ADDENDUM NO. 1

Lawnridge Park – Pickleball and Basketball
Courts; Project No. LB6189
Grants Pass, Oregon 97526

LIGHT POLE FOUNDATION

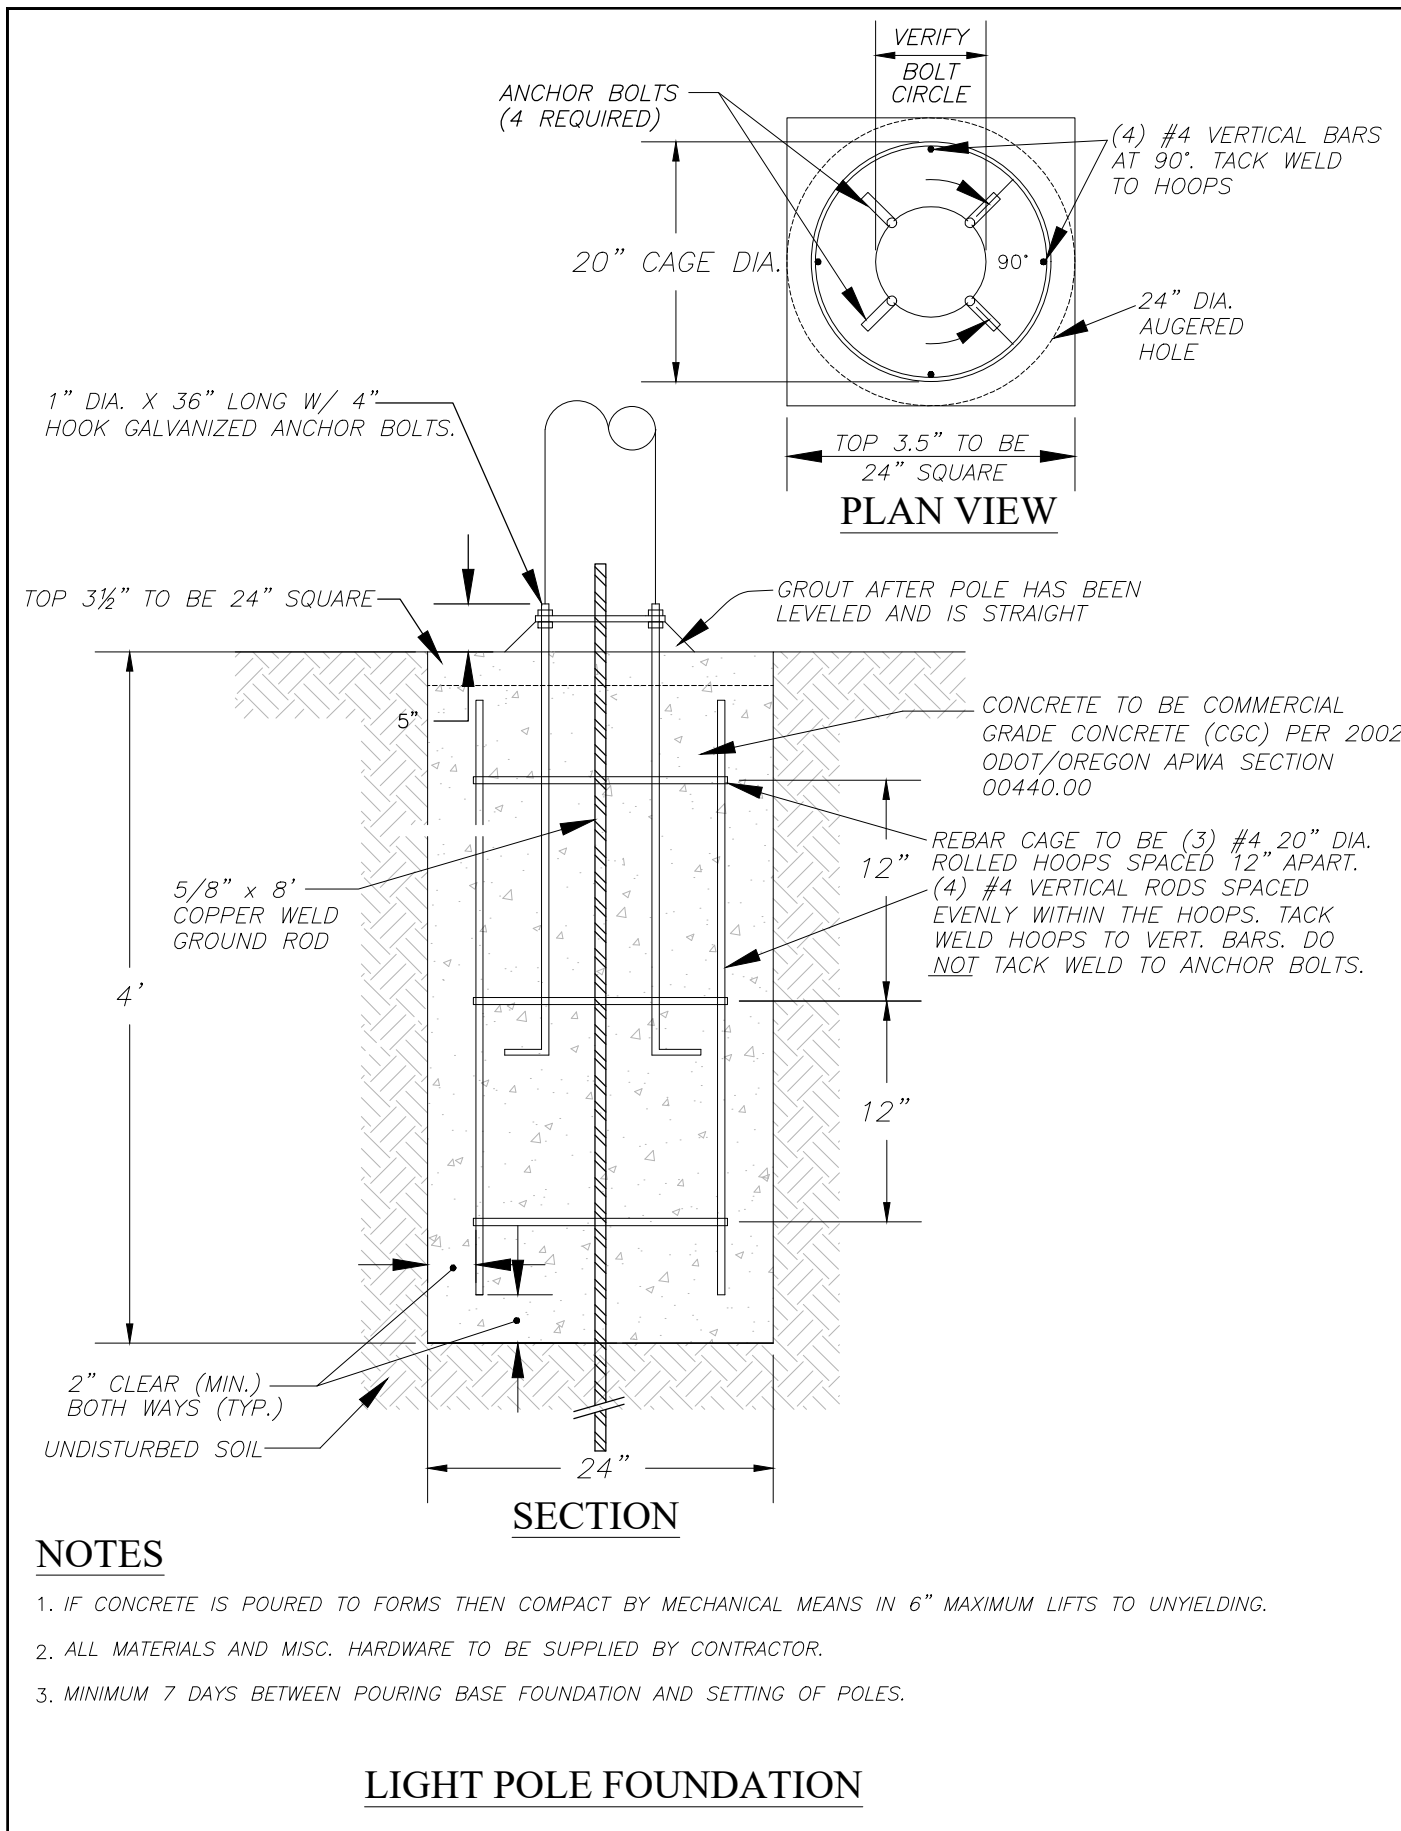
- Included in addendum is Light Pole Foundation Detail sheet, see final page of addendum.
- Fence quantities are:
 - 4' Green vinyl coated chain link fence between 2 Pickleball Courts: approx. 34'

1. IF CONCRETE IS POURED TO FORMS THEN COMPACT BY MECHANICAL MEANS IN 6" MAXIMUM LIFTS TO UNYIELDING.
2. ALL MATERIALS AND MISC. HARDWARE TO BE SUPPLIED BY CONTRACTOR.
3. MINIMUM 7 DAYS BETWEEN POURING BASE FOUNDATION AND SETTING OF POLES.
